Revision History	5
Preface	8
Summary Table of Changes	9
dentification Information	17
Non-Core Errata	19
Core Errata	43
Specification Changes	47
Specification Clarifications	51
Documentation Changes	61

# **Revision History**

## **Summary Table of Changes**

Table 236. DDR SDRAM Control Register 0 - SDCR0 (Sheet 1 of 2)

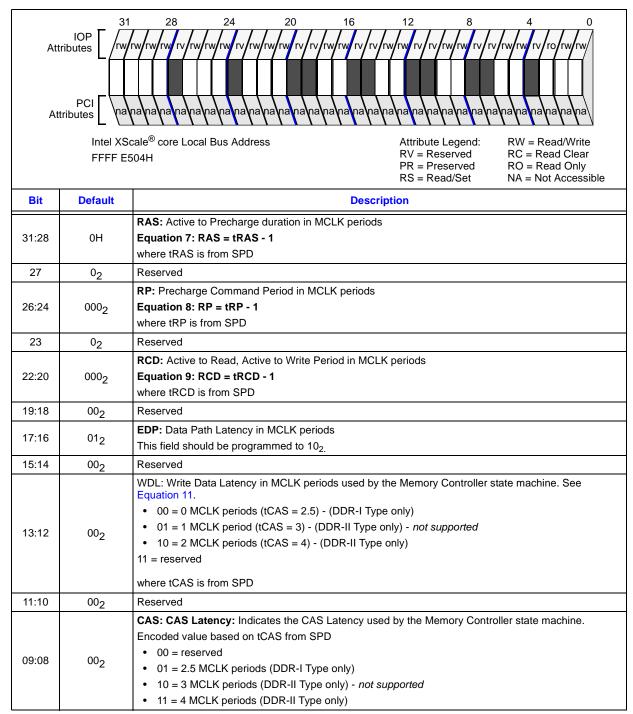
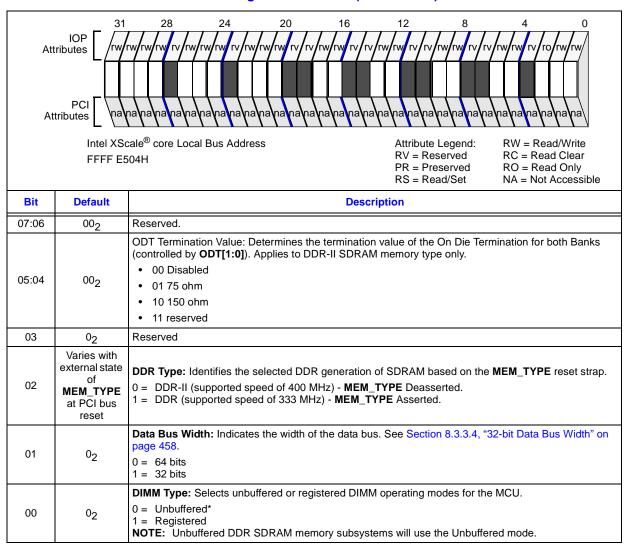
Workaround:
